Common Council
Tuesday, September 16, 2014
Agenda Item #1, Legistar #34903
Appeal of Plan Commission Decision on Conditional Use regarding 706 Williamson St.

I appreciate the opportunity to provide comments with respect to the appeal of the Plan Commission's approval of the conditional uses for the 706 Williamson project.

Commercial Block Building, Figure K12, MGO 28.173

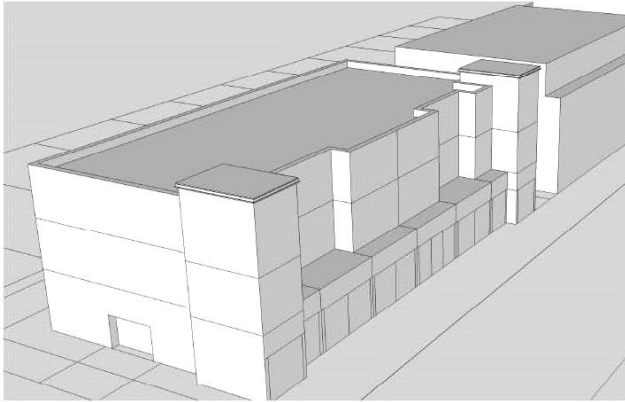
The 706 project is approximately 125 feet in length (site plans do not provide dimensions). The corner element is about 30 feet of glass, the step-back (street number) is about 10 feet, and the remaining approximate 85 feet is glass. The project lacks:

- storefronts, stoops or patios (unless 5 foot setback from the sidewalk counts as a patio);
- vertical articulation every 40 feet;
- clearly visible entries identifiable from the street;
- entries that are delineated with elements such as roof overhangs, recessed entries, landscaping;
- a building base that relates to the human scale, including doors and windows, texture, projections, awnings, canopies.

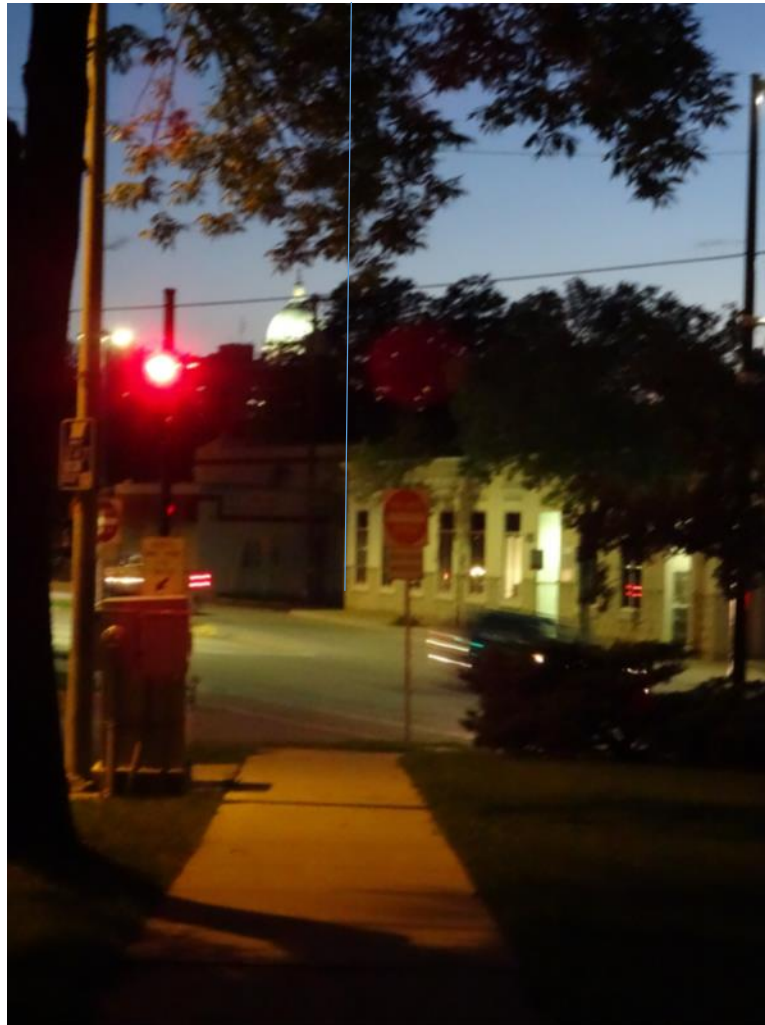
The Comprehensive Plan, though a supplement (Downtown Plan, adopted by the City of Madison Common Council as a supplement to the Comprehensive Plan, 7/17/2012, RES-12-00564), has protected views, one of which is the Jenifer Street view of the Capitol.
